Design Advisory Board

Tuesday, September 9, 2025, 3:00 PM

ZP-25-298; 506 Appletree Point Road (RL, Ward 4) Conrad Koerper IV / Pamela Koerper / Joshua Carel

To: The Design Advisory Board
From: Mary O'Neil, AICP, Principal Planner
RE: ZSP-25-8, ZSP-25-9, ZSP-25-10
Location: 77, 83-85 and 91 North Winooski Avenue
Date: September 9, 2025

SHEET NAME:
ARCHITECTURAL SITE
PLAN

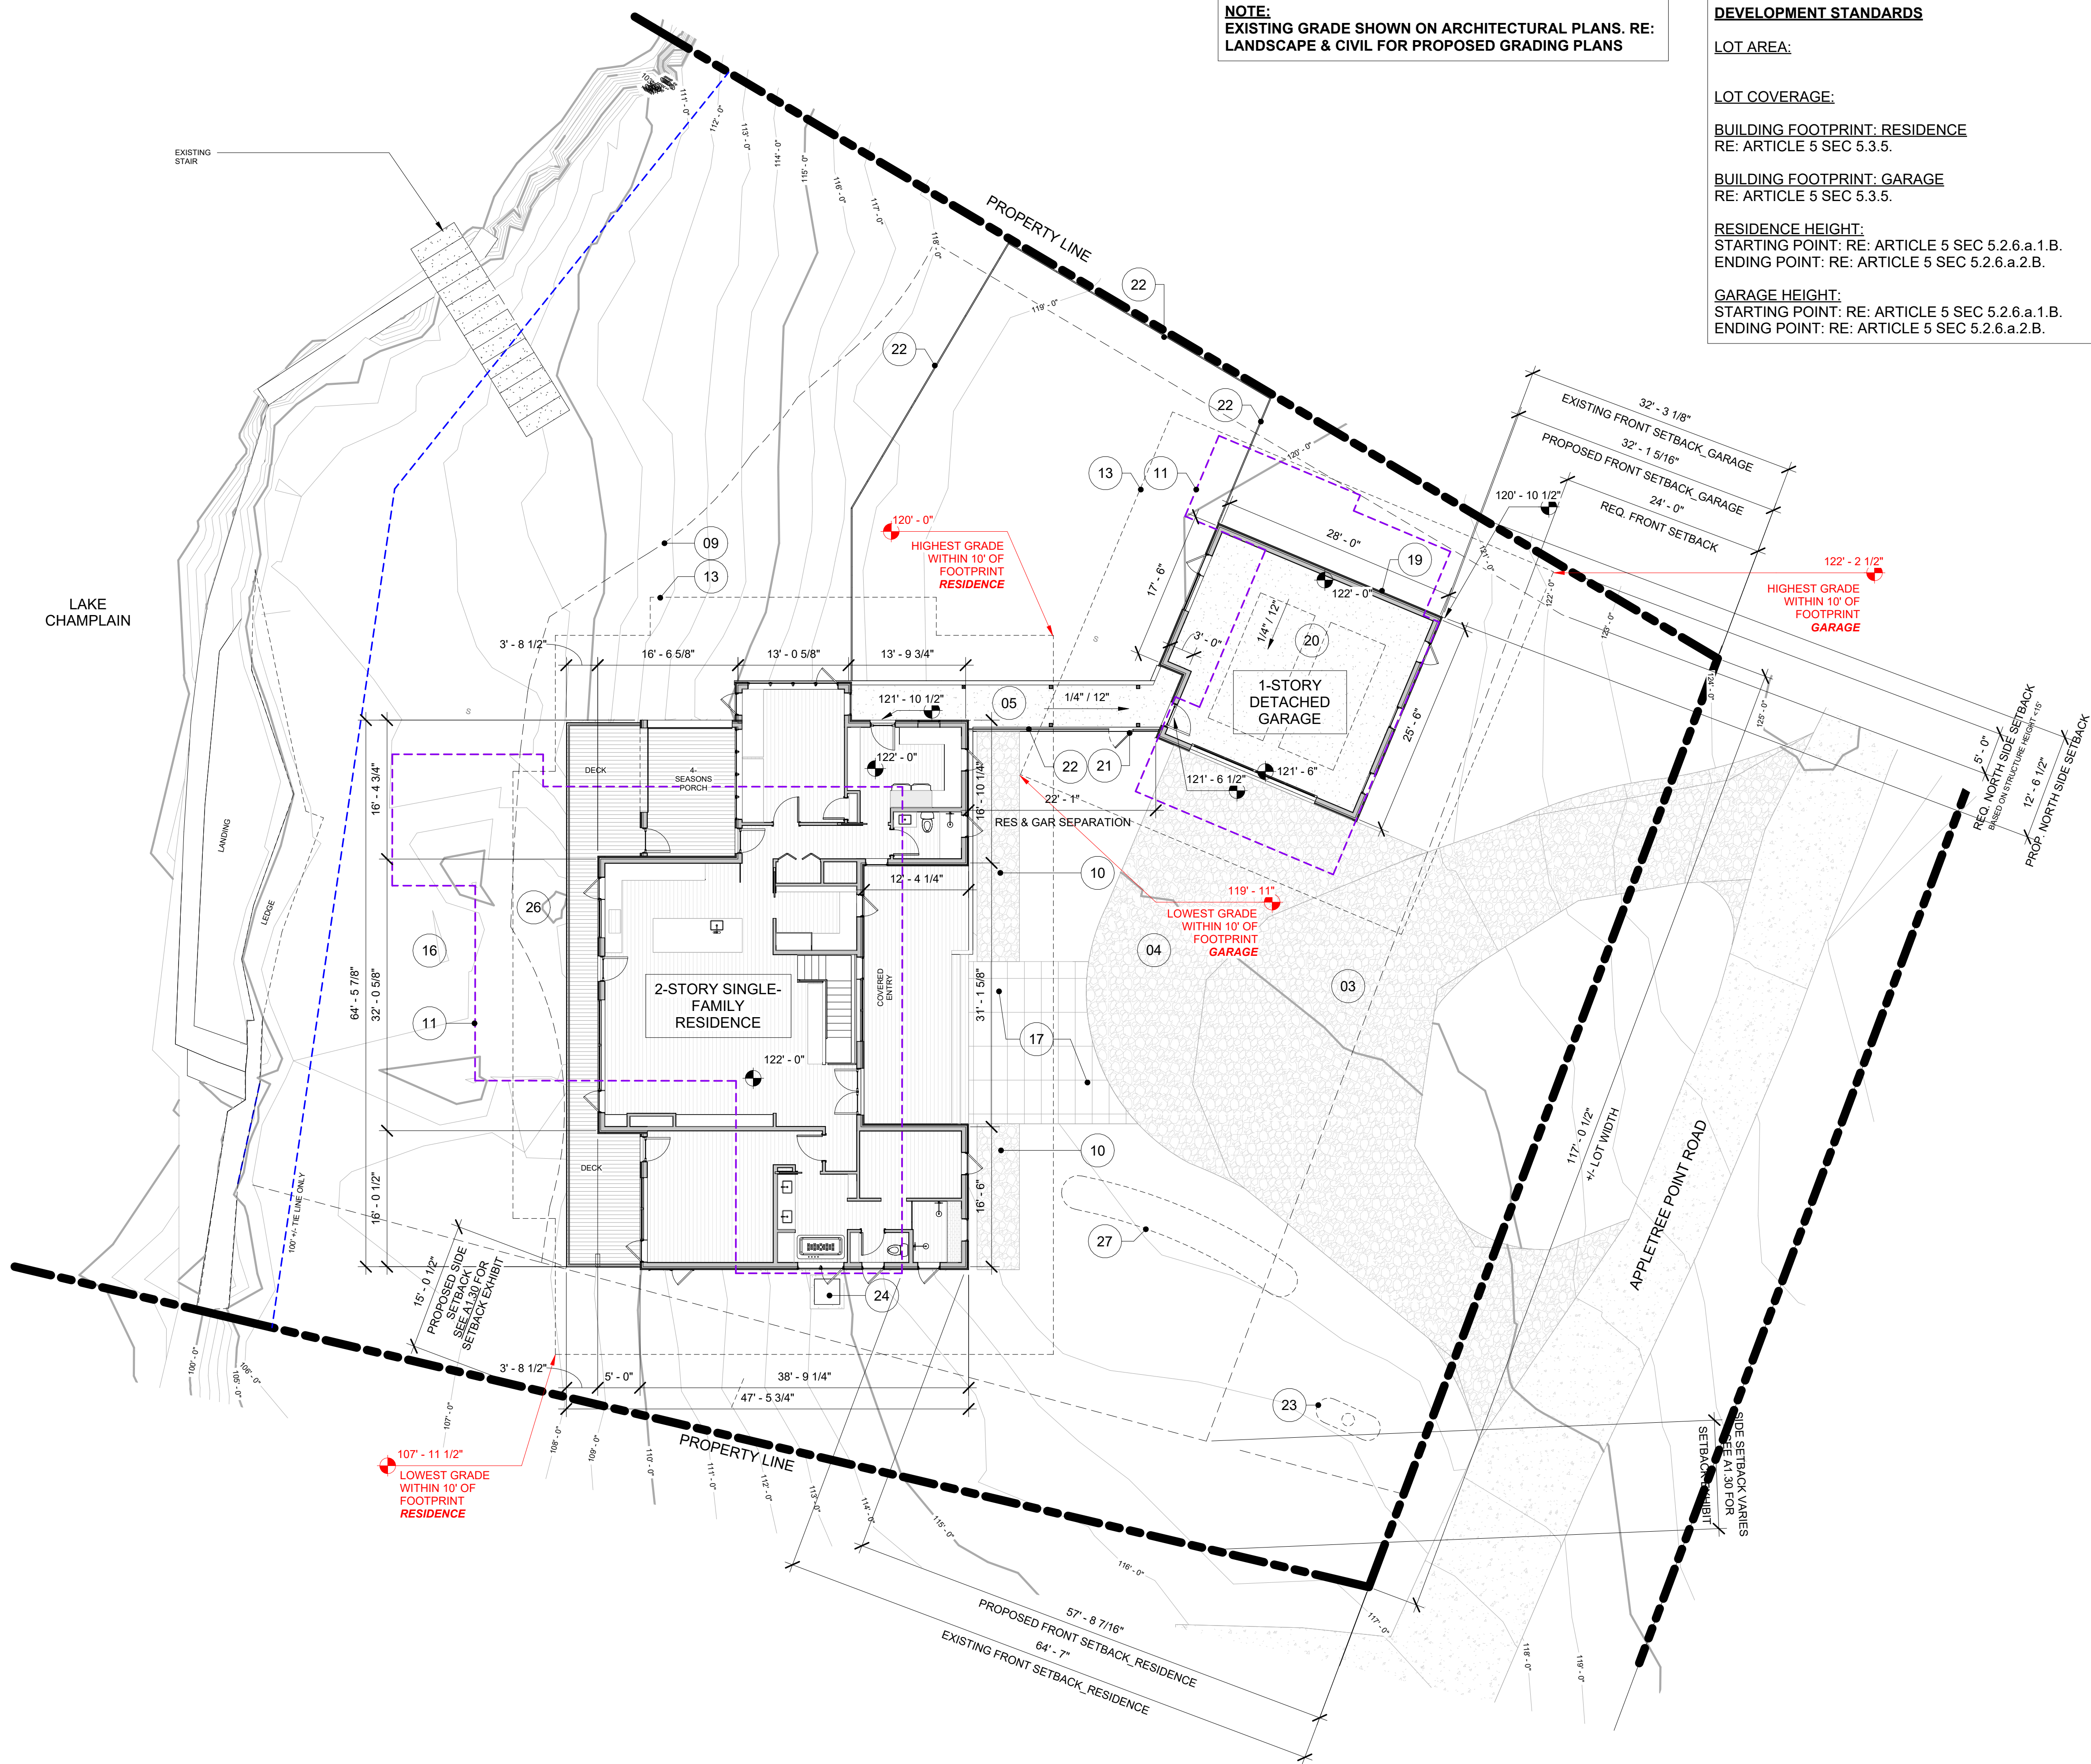
The proposed A/C condenser will be below the grade of the front of the home and will not be visible from adjacent properties or the road. A utility meter is proposed for the north elevation of the garage and will require screening by vegetation or other methods.

1. Erosion control and stormwater management plans are needed, subject to Water Resources review and approval.
2. Revised project plans addressing the following are needed:
 - a. Lumen information for the exterior light fixtures; and,
 - b. Screening of the utility meter(s).

ROOF PLAN

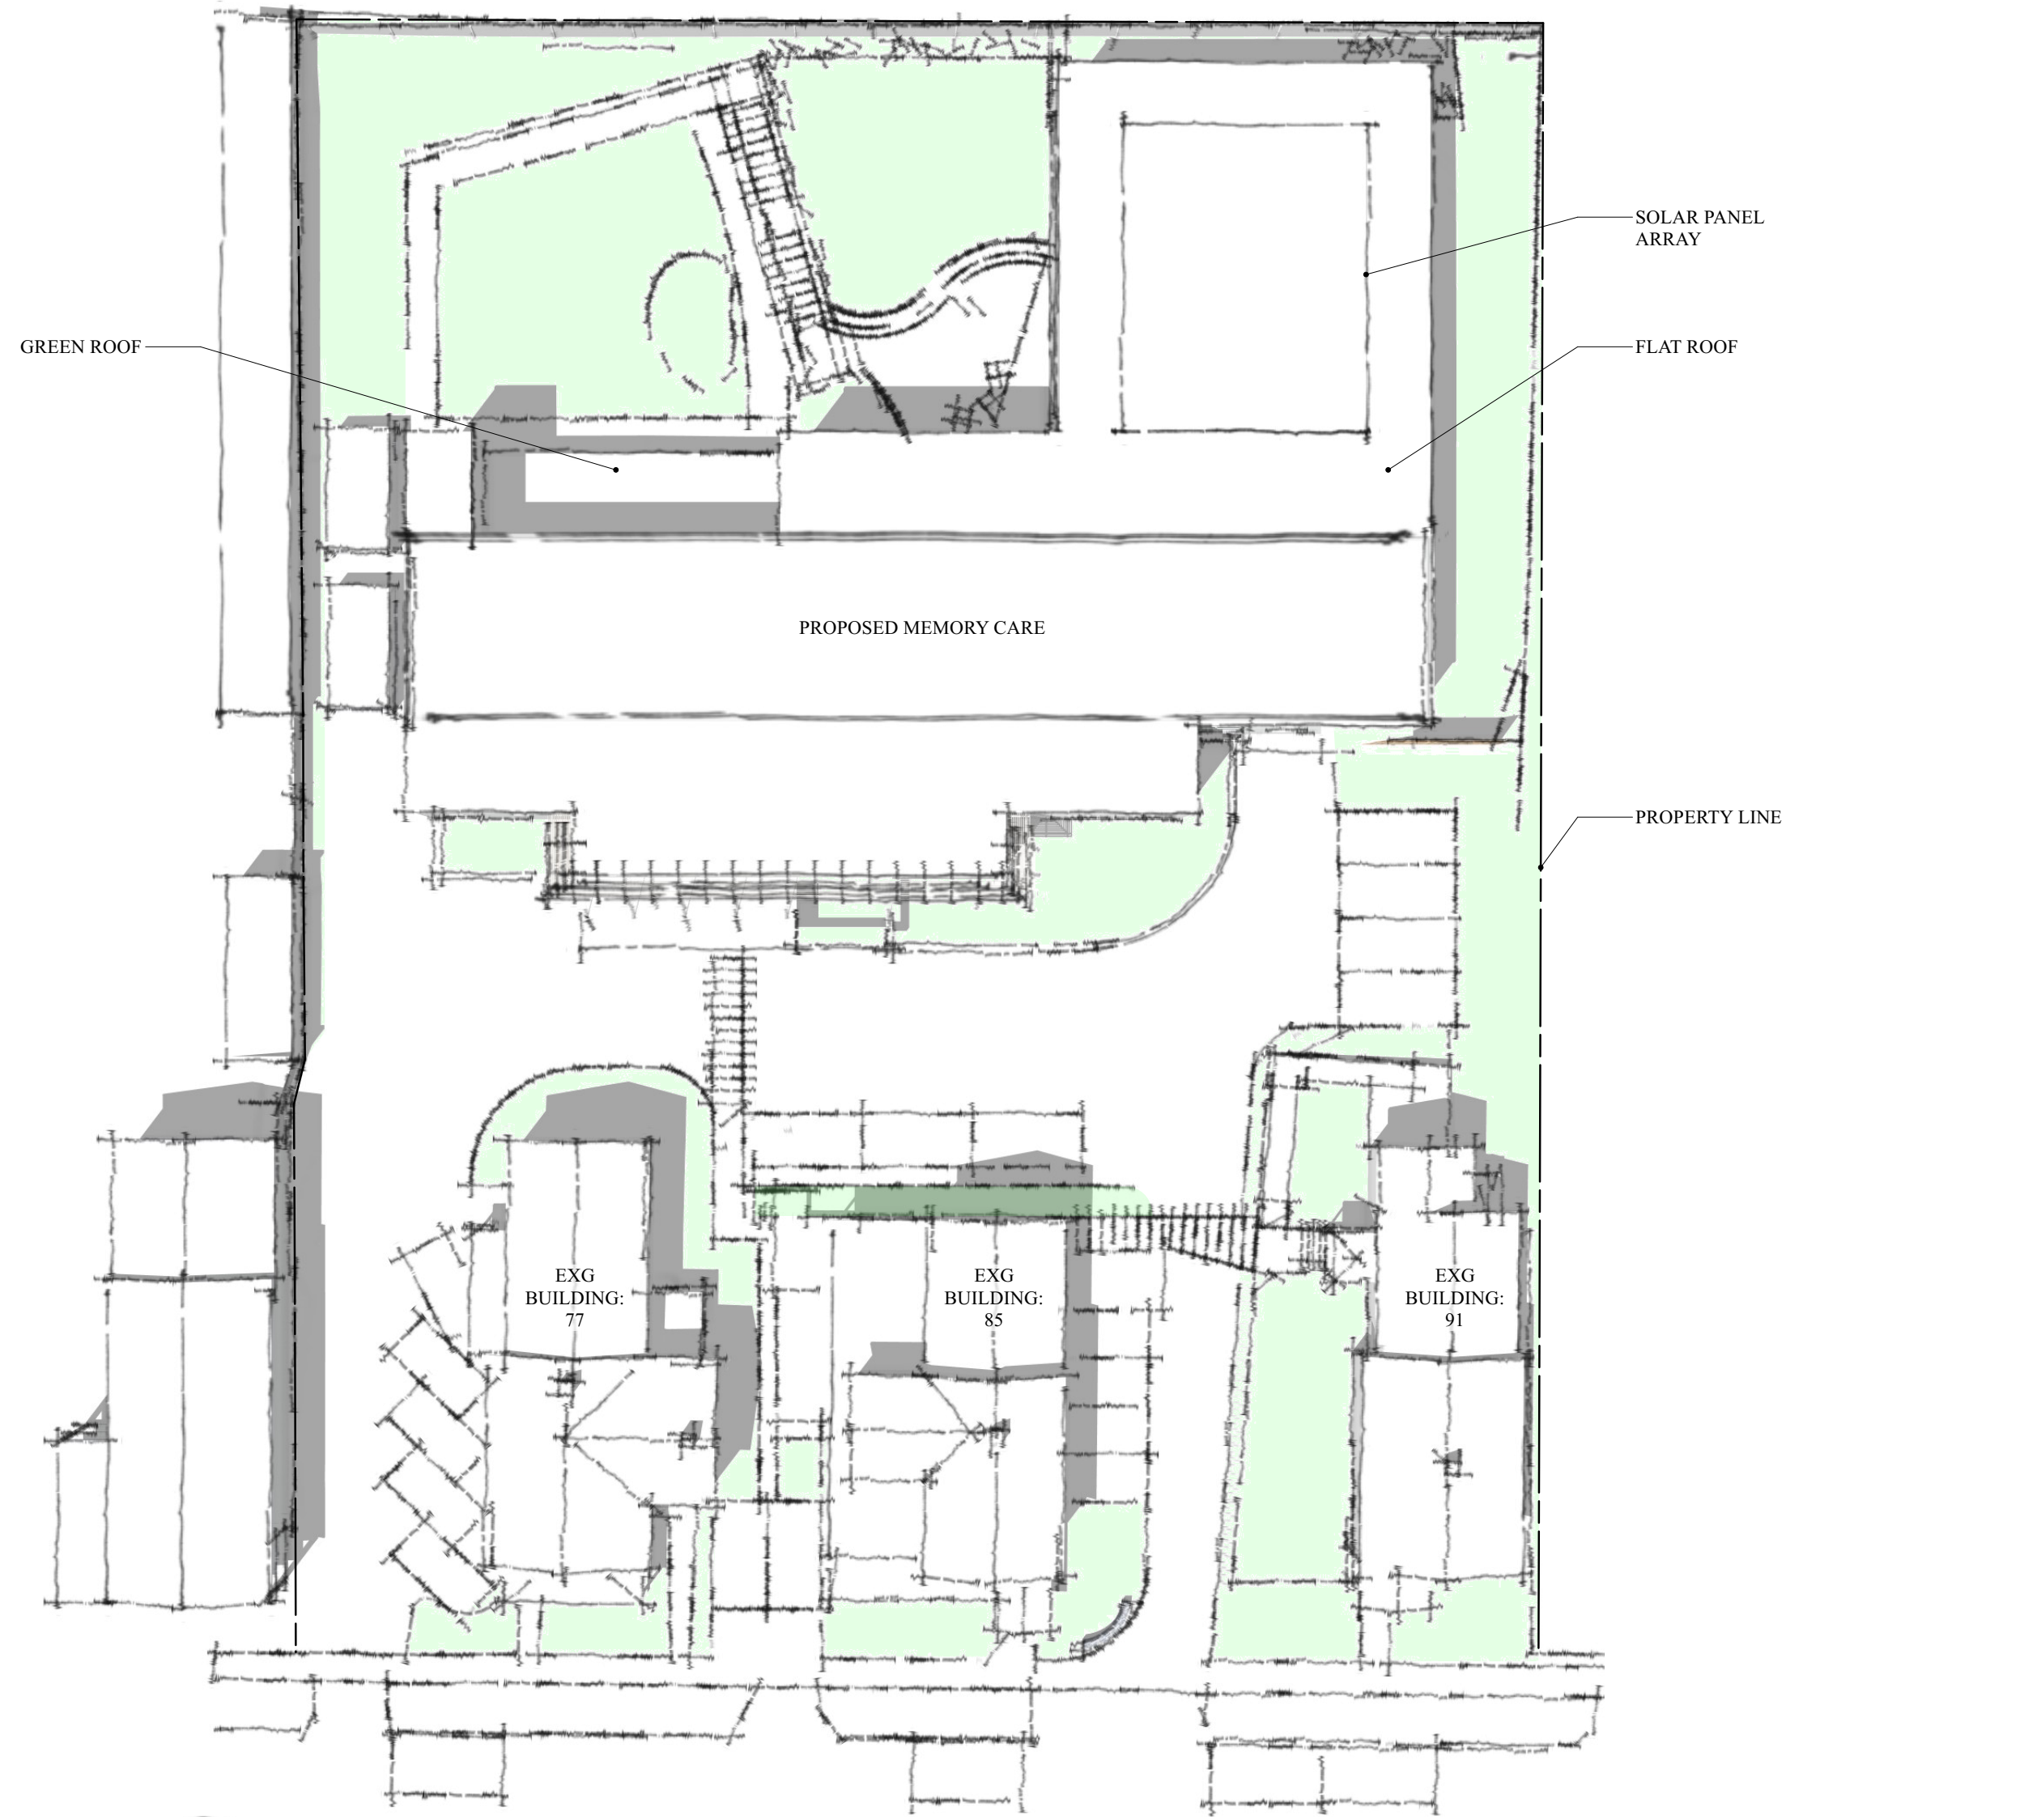
The roof plan defines the intent to utilize solar on the roof of the Memory Care building. The project will be required to comply with **Chapter 8, Buildings and Building Constructions, Article V, Heating Systems of the Code of Ordinances** (Burlington's Thermal Energy Systems Carbon Fee Ordinance.)
